REQUEST FOR INFORMATION NOT ADDRESSED IN THIS CCO REMAIN IN FORCE

MARK	DATE	DESCRIPTIONS	BY	CH'D	CCO#
1	02/19/08	ELECTRICAL MODIFICATIONS	MP EL	RR	42

DETAILS
SAS SUPERSTRUCTURE ROADWAY EASTBOUND PANEL UP-205 SCHEDULE
NO SCALE

E-151

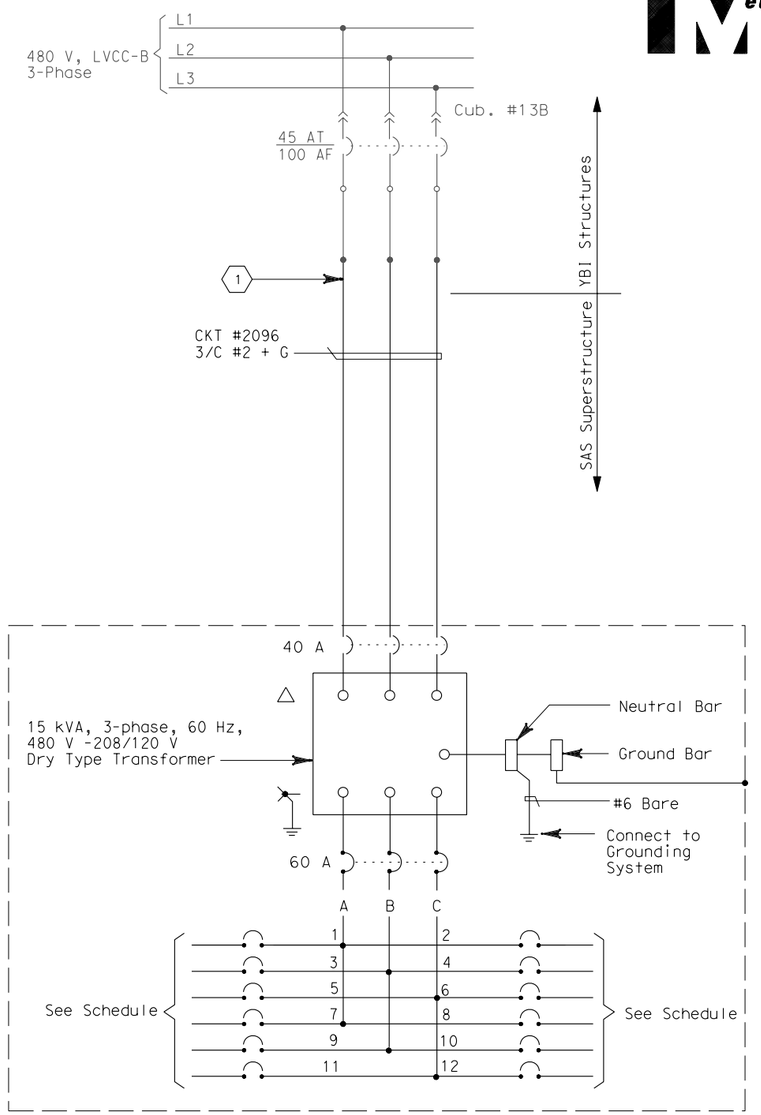
UTILITY PANEL UP-205 (CKT #2096)

LOAD DESCRIPTION	LTG	REC	OTH.	CB		CB	LTG	REC	OTH.	LOAD DESCRIPTION
Recept (2) Eastbound North Barrier		360		20/1	1 A 2	20/1			10	CB-242A
Spare				20/1	3 B 4	20/1			20	CB-242B, 242C
Recept (2) Service Platform #5		360		20/1	5 C 6	20/1				Spare 1
Recept (2) Girder		360		20/1	7 A 8	20/1	738			Girder Lighting (18)
RTU #10E (PLC Power Supply)			100	20/1	9 B 10	20/1				Spare
RTU-#10E (Lighting & Receptacle)	105	180	150	20/1	11 C 12	20/1				Spare
TOTAL WATTS	105	1260	250				738		30 1	TOTAL VA
